Application No. 10/628,556
Amendment dated October 5, 2005
Reply to Office Action of April 6, 2005

Amendments To The Drawings:

- REMARKS/ARGUMENTS -

Attachment: Appendix A - Replacement Sheets (4) & Annotated Sheets (4)

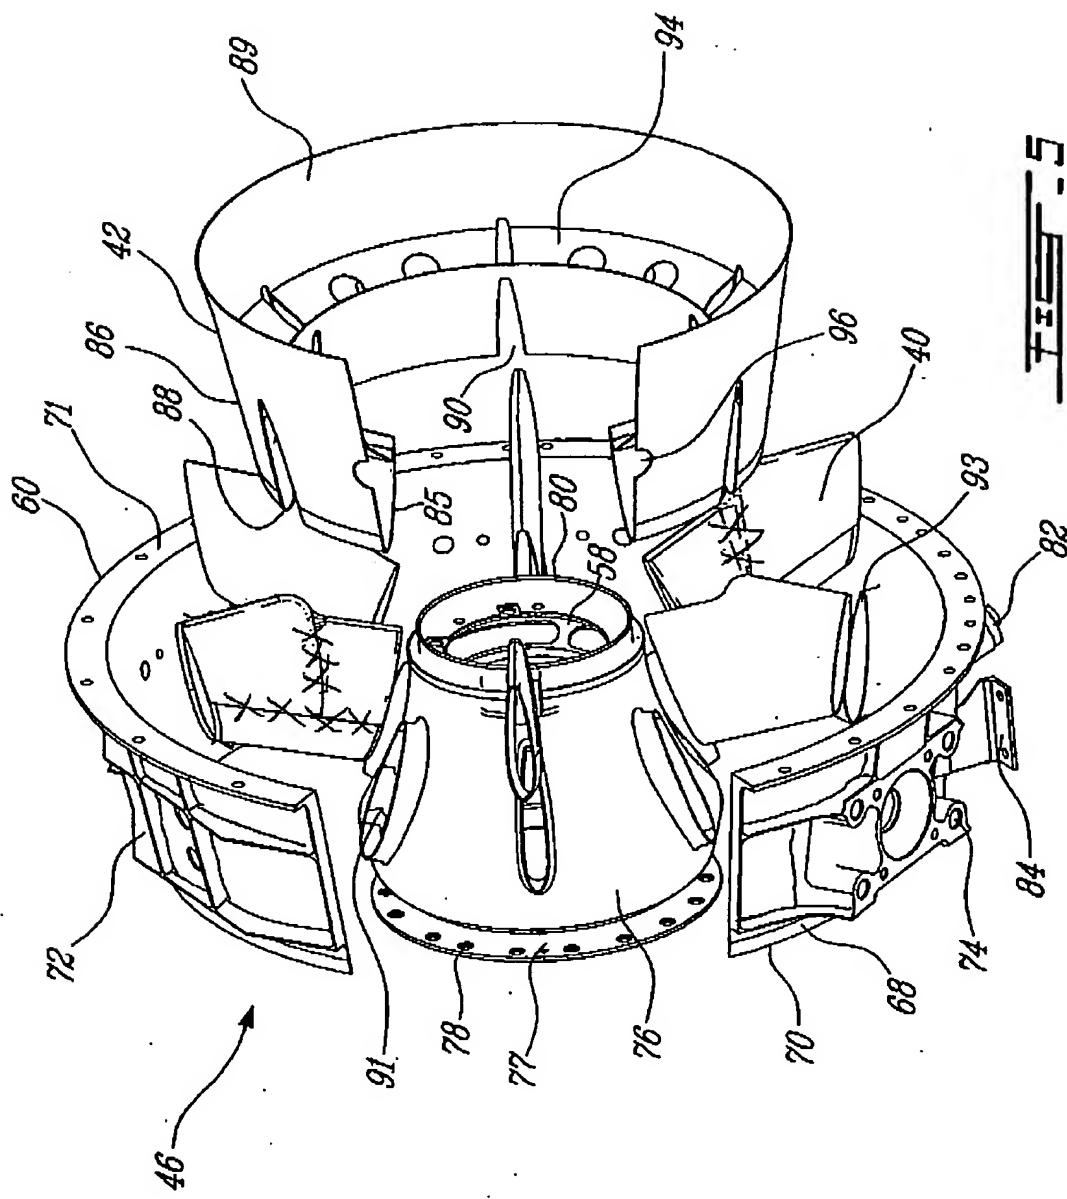
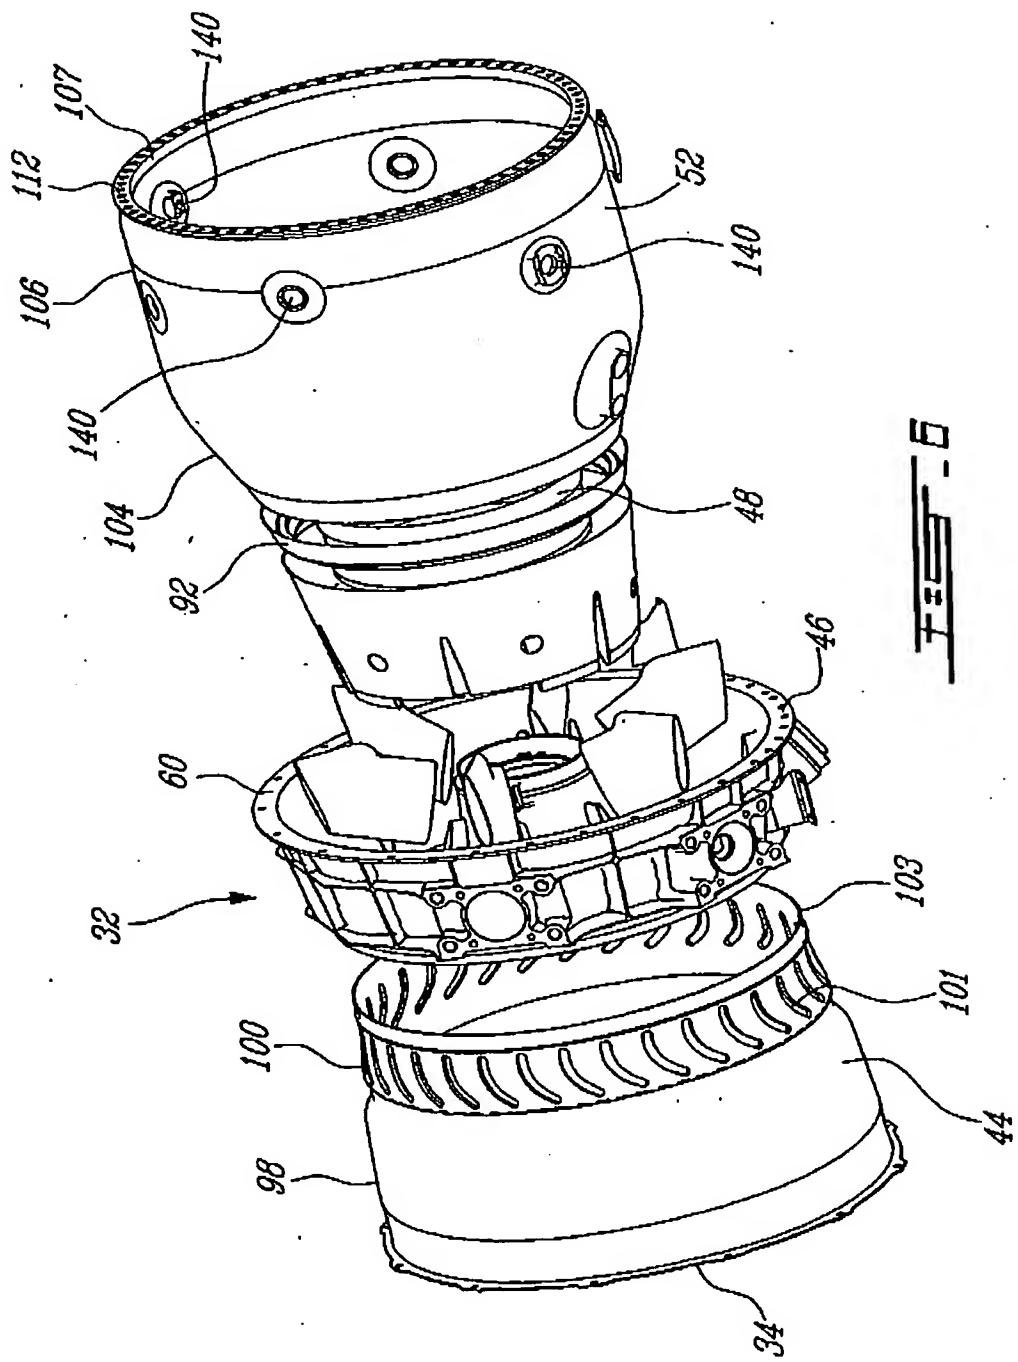
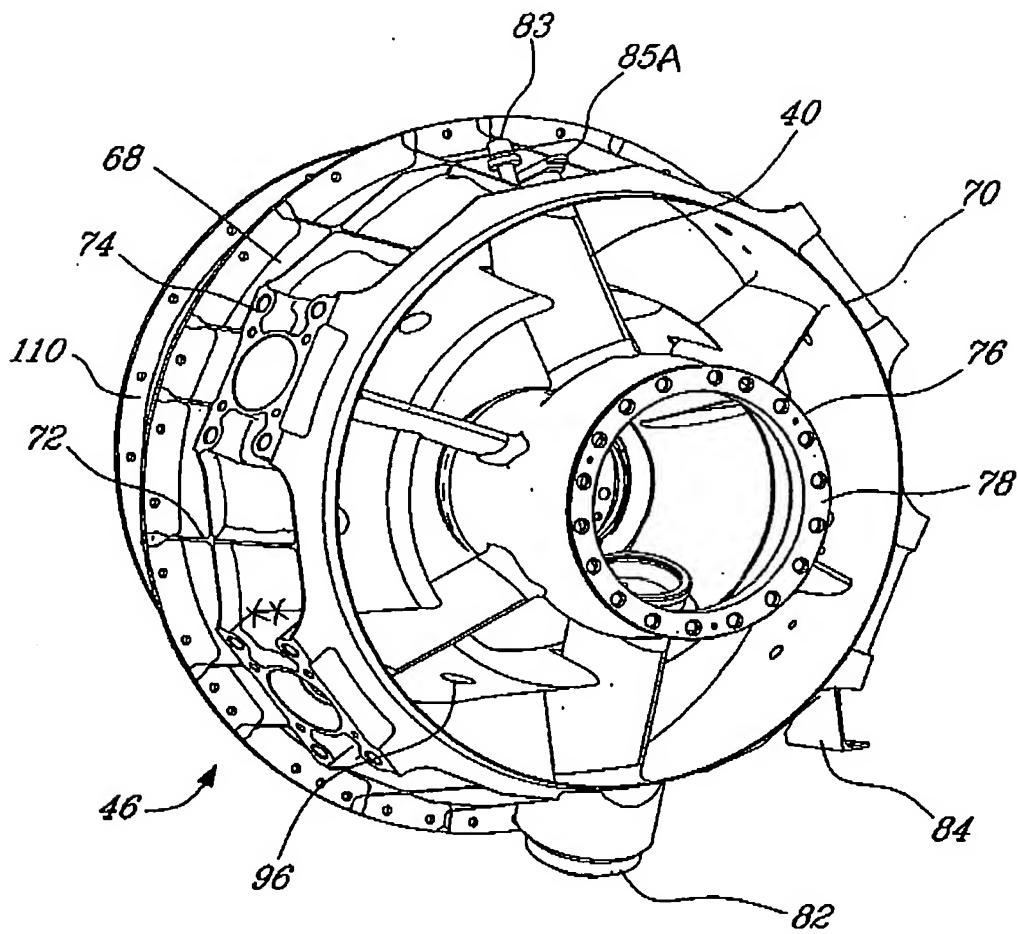
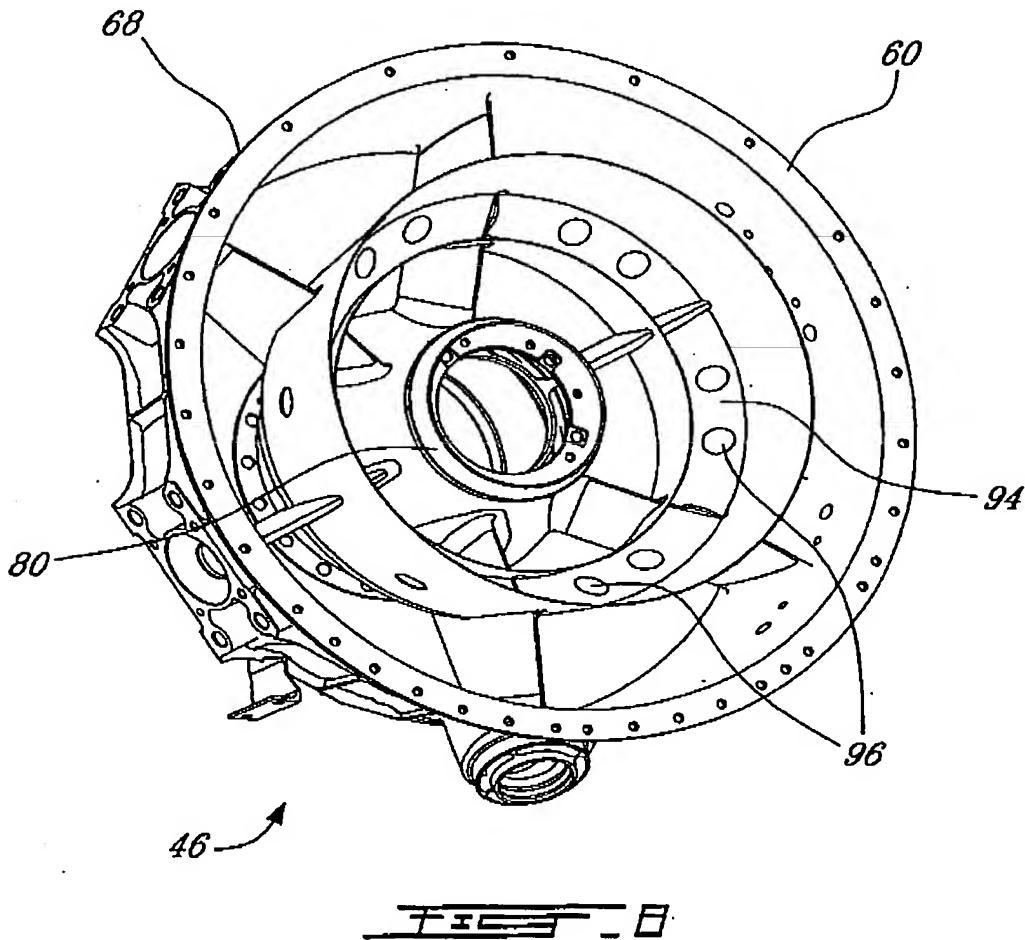
The attached sheets of drawings include changes to Figures 5, 6, 7 and 8 with respect to the drawings submitted January 15, 2004.

The Examiner has objected to the drawings of Figures 5, 6, 7 and 8 submitted on November 4, 2004 because they were not labelled as "Replacement Sheet", and has further identified reference character "85" as being used to designate both the probe boss (paragraph [0040]) and the annular inner wall (paragraph [0042]).

Therefore, Applicant resubmits the drawings of Figures 5, 6, 7, and 8 which are now labelled in the top margin as "Replacement Sheet" pursuant to 37 CFR 1.121(d). The replaced drawings of Figures 5, 6, 7 and 8 have been amended to more clearly indicate details of the figures which were included in the originally filed informal drawings but were inadvertently omitted from the formal drawings submitted on January 15, 2004. It should be noted that the annotated sheets of Figures 5, 6, 7 and 8 submitted herewith, show the changes with respect to the formal drawings submitted on January 15, 2004.

The defect of double use of the reference character "85" has been corrected in the replacement sheet of Figure 7 by changing reference character "85" (indicating the probe boss) to reference character "85A".
